AMENDED AGENDA -- PLAN COMMISSION
Tuesday, March 3, 2020
6:00 P.M.

Staff Report to the Plan Commission

3a. Plan Commission Use and Occupancy Review, GoPuff (GoBrands, LLC), 6120 North Baker Road. Review and approve warehouse and distribution of consumer products use and occupancy.

Proposed Architecture 2020: Modern Touch Dental and a Second Tenant

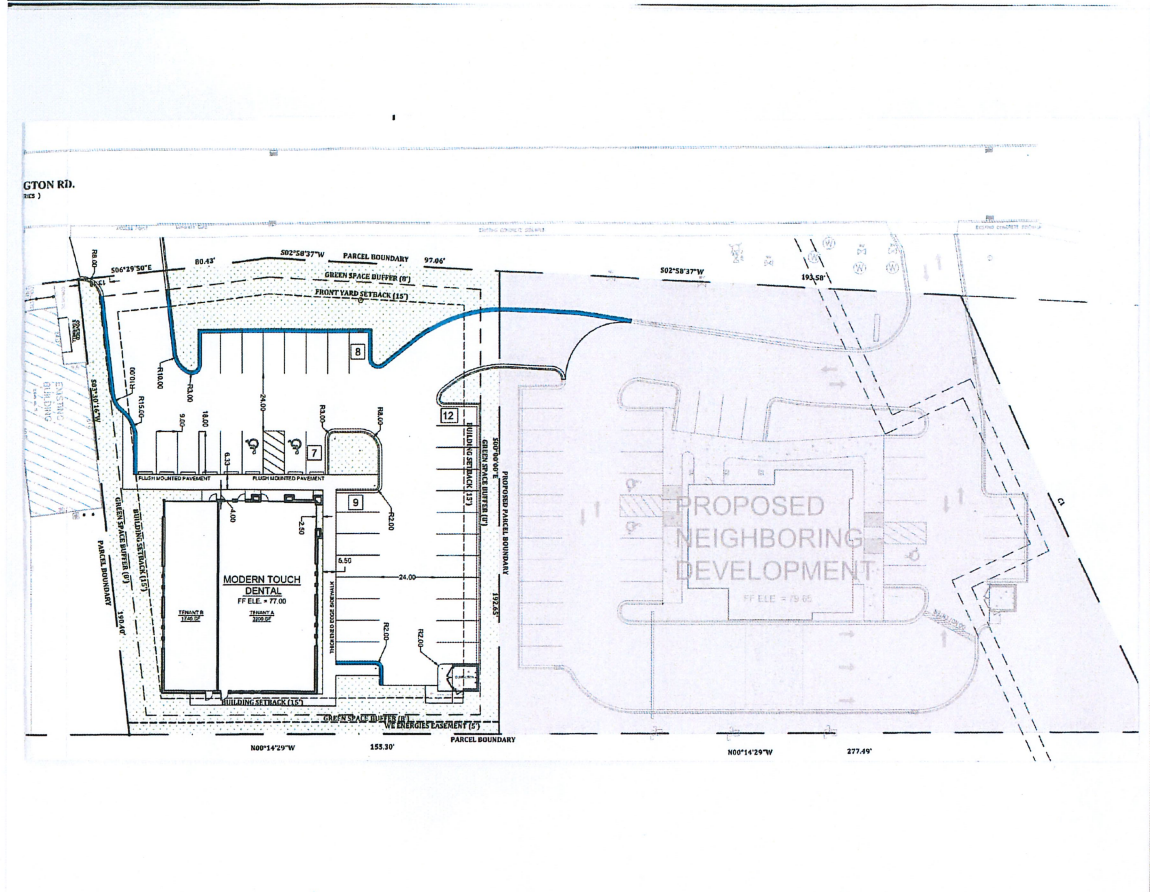
The proposed architecture is similar to what was presented previously with modest refinements to make the building suitable for two tenants rather than a single tenant. The architecture is modern and includes brick veneer on all four elevations, with the Modern Touch Dental entrance located at the northwest corner of the building to feature natural stone and Nichiha (Vintage Wood) siding material, and the entrance for the second tenant located to the south, where the façade there still includes the metal wall panel feature at the southwest corner, with clear glass window openings in each of the four building elevations (Refer to submittal materials).

Site Plan Exhibit

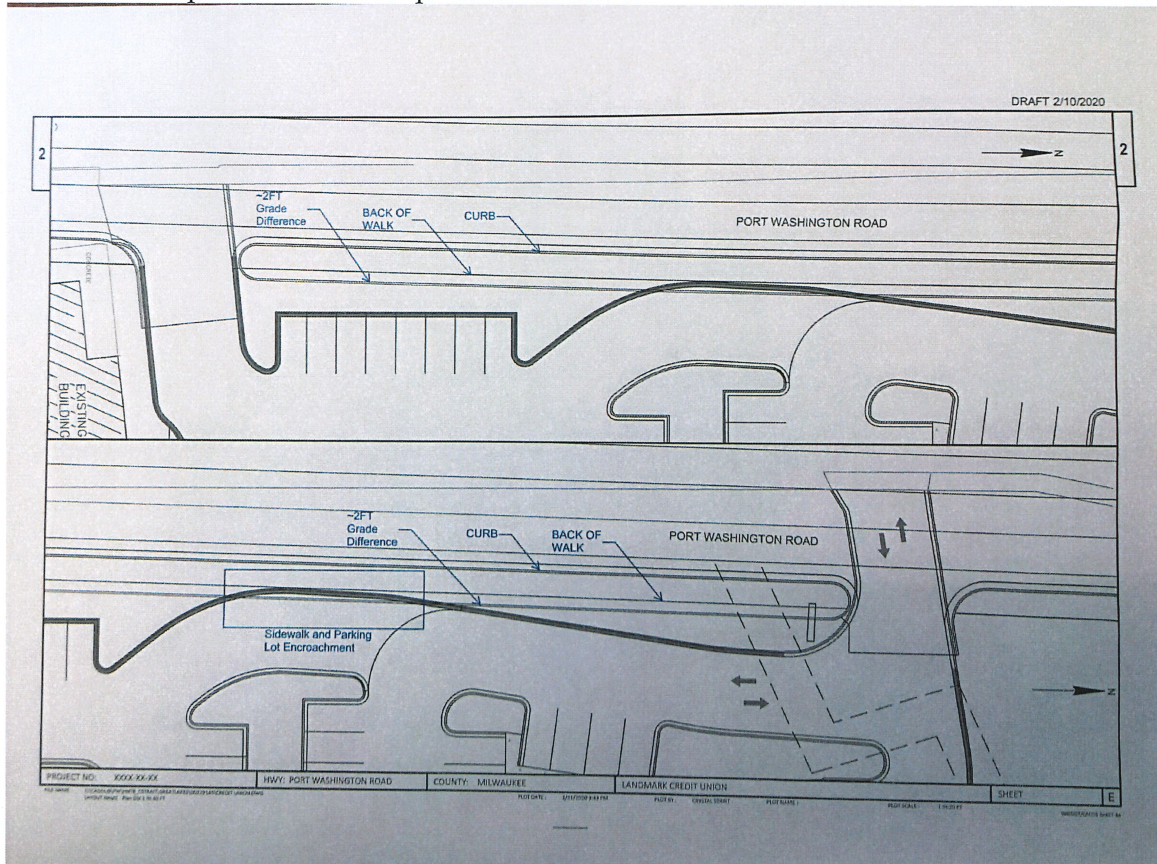
The larger site was previously occupied by the Barrett Office Park and is presently vacant. The proposed building will be located on Lot 2 of the Certified Survey Map that the Plan Commission reviewed and recommended reviewed and recommended to the Common Council October 1, 2019, and the Common Council approved October 14, 2019. The Lot 2 property will be about 0.7431 acres (32,368 square feet) of land. The submitted plan indicates that the project will include 0.48 acres of impervious surface and 0.26 acres of green space, as compared with the previous/existing 0.52 acres of impervious surface and 0.22 acres of green space, with the resultant proposed green space ratio being 35.65 percent of Lot 2. It is not certain at this time as to whether the Certified Survey Map, which has not yet been signed and recorded, will be modified to accommodate the Wisconsin Department of Transportation right-of-way acquisition.

The building placement is in the southeast corner of the property, with the main entrance located at the northwest corner of the building, with a pedestrian sidewalk around the west, north, and east sides of the building, and 36 (previously 38) parking spaces along the north and west sides of the

The revised site plan reintroduces a drive lane connecting the north and south parcels, as was originally conceived when the Landmark Credit Union was presented to the Plan Commission. Ingress and egress to Lot 2 is proposed at the south end of the property, which approximates the location of the existing property ingress-egress placement.

The imminent plans of the State of Wisconsin Department of Transportation to reconstruct and realign the railroad bridge and Interstate Highway 43, and the related widening of North Port Washington Road from two to four lanes, will impact the west edge of the property and will also impact existing segments of sidewalk. The property owner is aware of this reality and has been working with the Wisconsin Department of Transportation to minimize and resolve modest impacts to the development site (Refer to Wisconsin Department of Transportation Exhibit).

1 PROPOSED PHOTOMETRIC LIGHT LEVELS CALCULATIONS PLAN

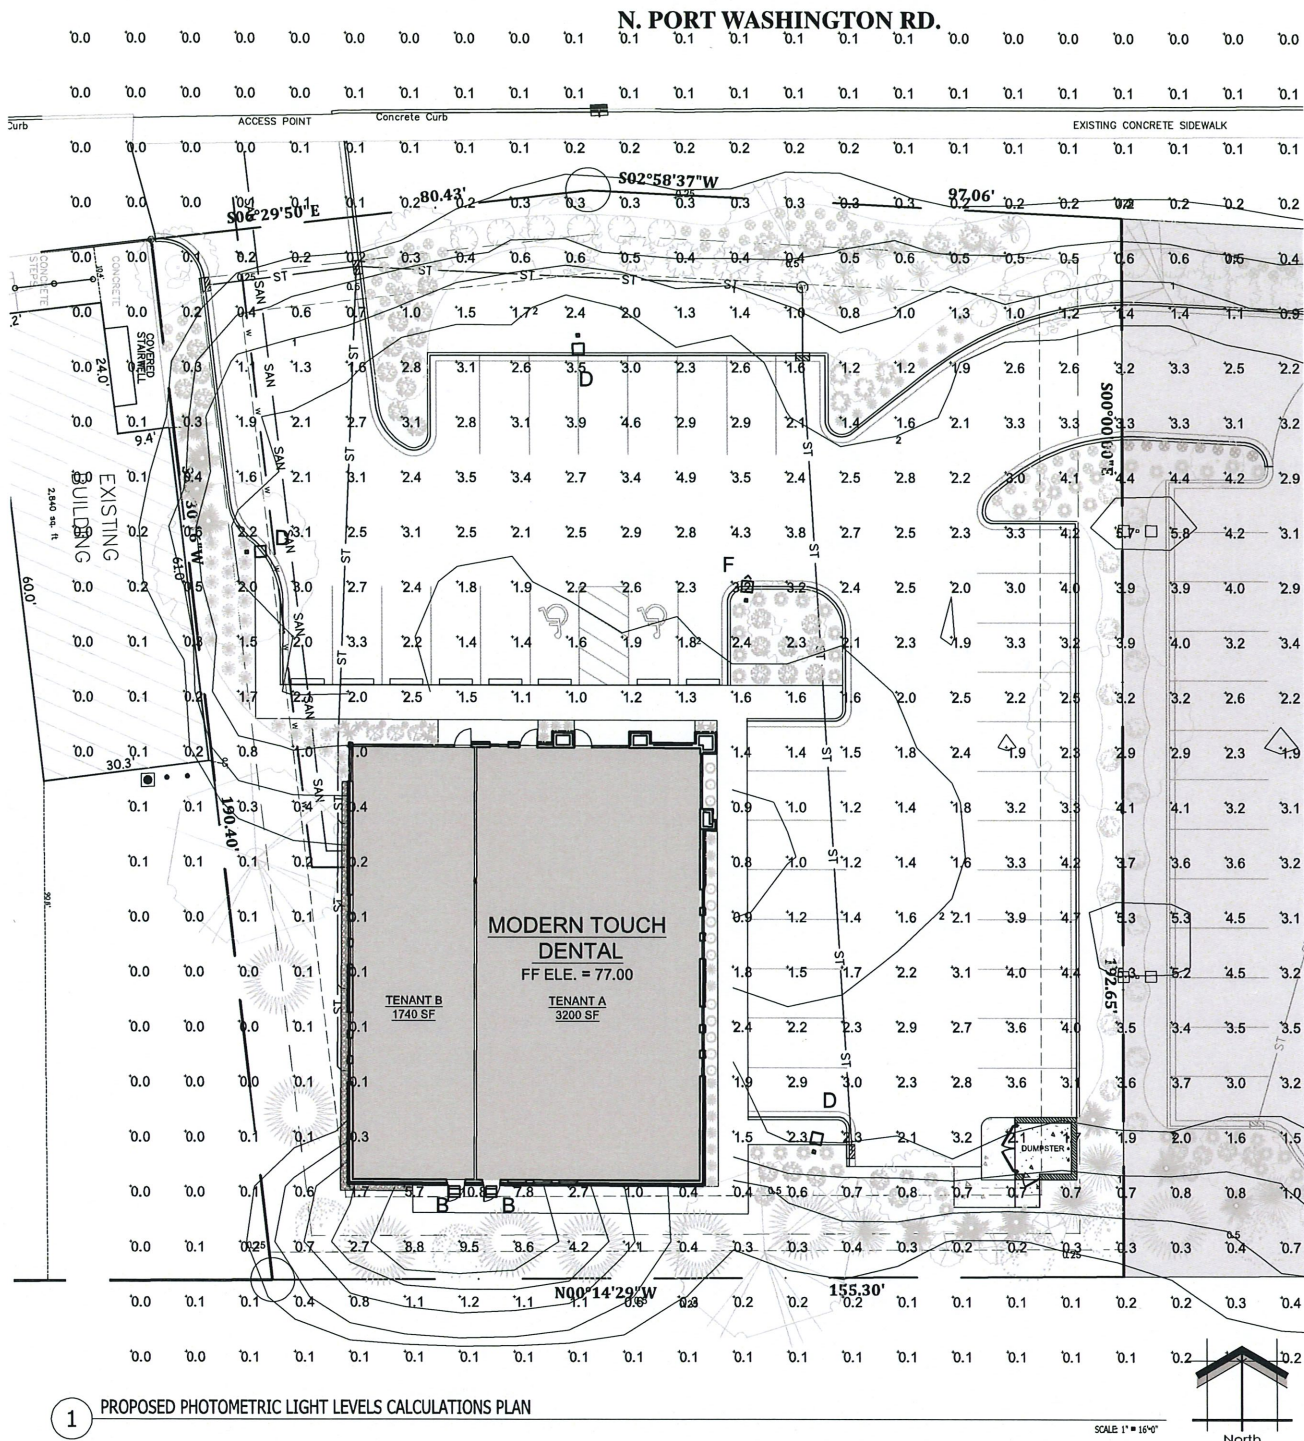
Proposed lighting includes pole mounted lights at a height that exceeds what is permitted, wall mounted, and ground mounted illumination. The Glendale Zoning Code limits the height of light poles to 15 feet total height. Proposed signage includes a wall sign above the main entrance and the second tenant entrance in the west elevation. Site landscape beautification is generous with interspersed areas of planting beds and grass turf across the property.

2. Light pole height is limited to 15-foot height;
3. Signage requires a permit(s) per the Glendale Sign Code;
4. Submit stormwater management analysis and related drainage pattern analyses and grading and drainage plans for review and approval by the City Engineer and the Director of Public Works;
